SPRAY POLYURETHANE FOAM ALLIANCE

Subject: SPFA Comments on Proposed Modification to ICC AC-377 dated April 30, 2009

SPFA Comments to AC 377

Figure 1 (revised 5-11-09)

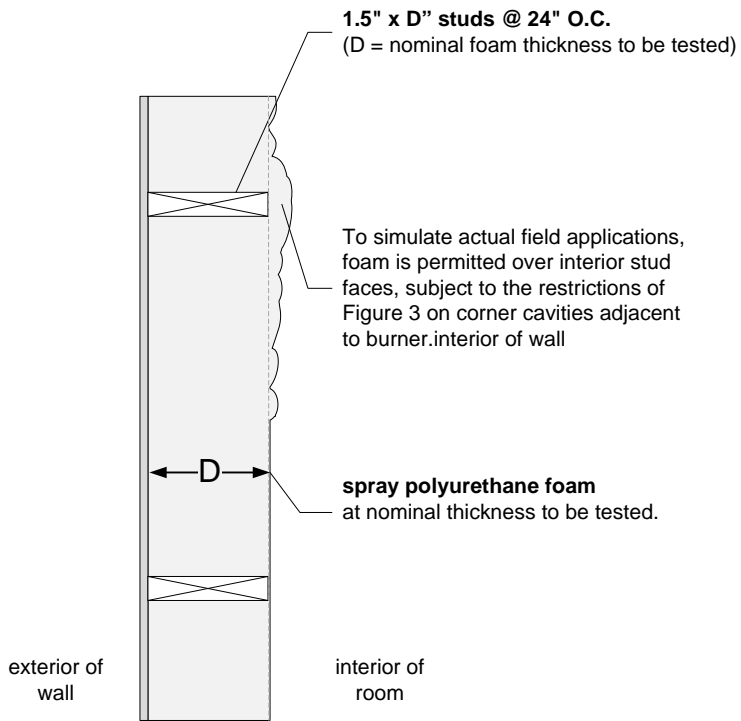
Comment – Appendix X – use revised Figures 1 and 2 that are attached.

Reason – Clarifies actual dimension of lumber.
